NRC-03-077

**KEWAUNEE NUCLEAR POWER PLANT  
DOCKET 50-305  
LICENSE No. DPR-43  
RESPONSE TO REQUEST FOR ADDITIONAL INFORMATION RELATED TO NMC REQUEST  
FOR THE USE OF GOTHIC 7 FOR THE KEWAUNEE NUCLEAR POWER PLANT  
CONTAINMENT DESIGN BASIS ACCIDENT ANALYSES**

REQUEST FOR ADDITIONAL INFORMATION  
GOTHIC 7.0  
TAC MB6408

**NMC's RESPONSE TO the NRC Staff's  
REQUEST FOR ADDITIONAL INFORMATION Concerning  
GOTHIC 7.0  
TAC MB6408**

**Figure 1 Phebus FPT0 Pressure – Best Estimate**

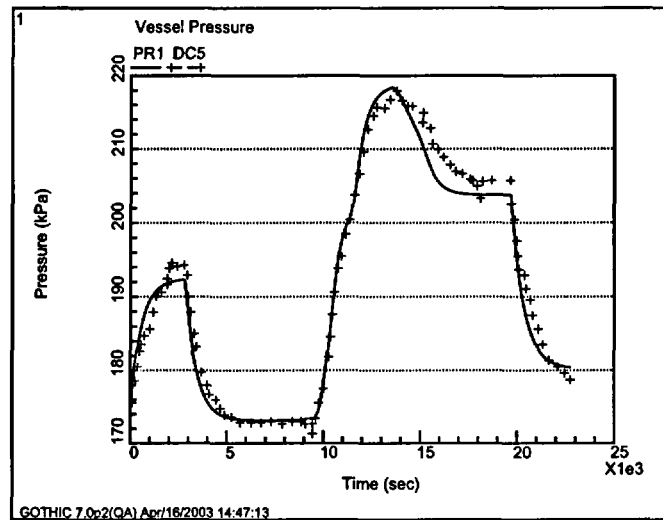
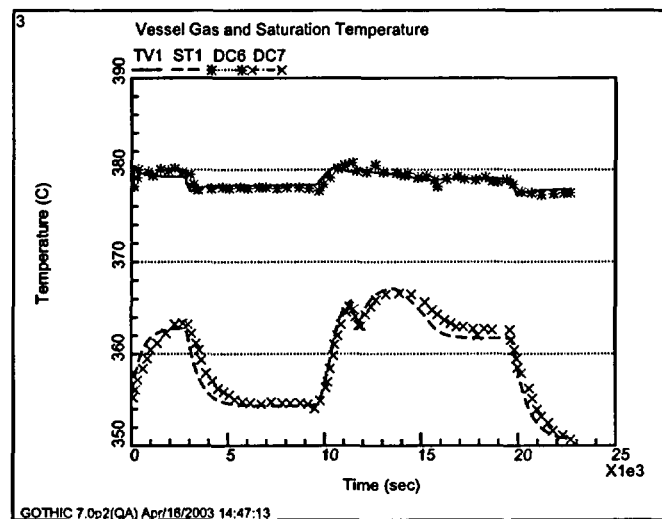
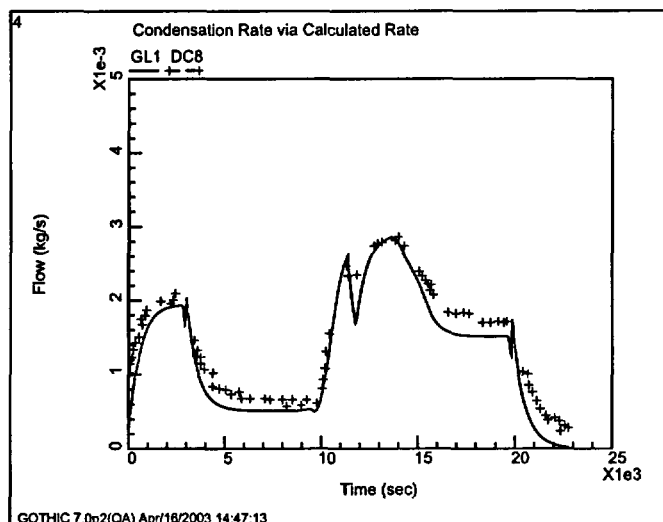
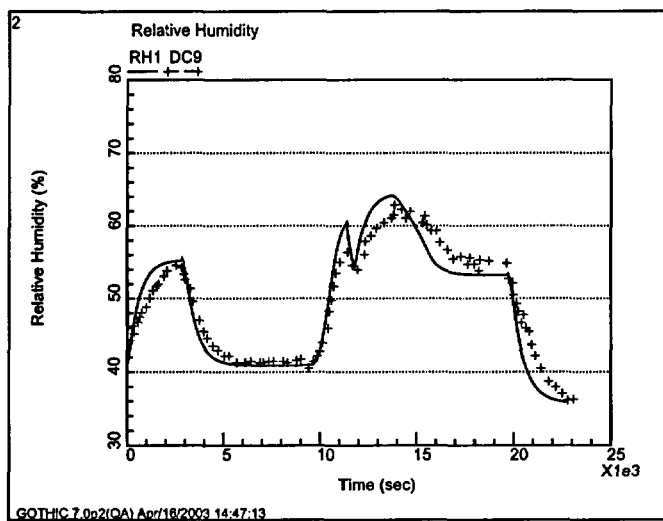
- (c) Phebus test FPT0<sup>3</sup> is an experiment performed by the Institut de Protection et de Surete Nucleaire (ISPEN) which included the measurement of thermal hydraulic conditions in a vessel with a superheated atmosphere. The NRC CONTAIN 2.0 code, using the heat mass transfer analogy, compares favorably with data from this test without a mist diffusion layer model<sup>4</sup>. Have comparisons been made between GOTHIC 7.0 with the results of this test? If no comparisons with this test have been made using GOTHIC 7.0, please perform a GOTHIC 7.0 calculation of FPT0. [The CONTAIN 2.0 input data are provided as an attachment to these questions for any assistance these data provide.]

**Response to 7(c):** The Phebus test FPT0 had not been used to qualify the GOTHIC MDLM option. Using the CONTAIN 2.0 input provided with the RAI, a GOTHIC model was constructed for Phebus test FPT0. The model was similar to the CONTAIN model, using a single lumped volume for the containment and a small sump volume to collect the condensate. Results for the pressure, temperature, humidity and condensation rate are shown in Figures 1 through 4. In these figures, the symbols represent the measured Phebus data as digitized from the figures presented in [16] and the lines represent the GOTHIC results. The original test report was not available so we do not know the accuracy of the test measurements or the accuracy of the test description. There is generally good agreement for all parameters, probably within the uncertainty in the experiment. Most of the difference between the measured and predicted pressure can be eliminated by a change in the cold wall temperature of 0.5C or a change in the initial humidity of 1%. Results are also presented (Figures 5-8) for the same test case with the conservative factor used for the Kewaunee analysis (0.717) applied to the MDLM heat and mass transfer coefficients. The pressure is significantly over predicted at all conditions. There is a smaller relative impact on the vapor temperature but the predicted temperature generally exceeds the measured value. There is only small changes to the condensation rate. For this test, when the conditions are steady, the condensation rate must match the steam injection rate to obtain the steady conditions. Therefore, the condensation rate at the steady conditions is the same with or without the multiplier. However, to achieve the same condensation rate with the conservative multiplier, the steam concentration must be higher as evidenced in the graph for the humidity. This is also reflected in the higher pressure and temperature when the conservative multiplier is applied.
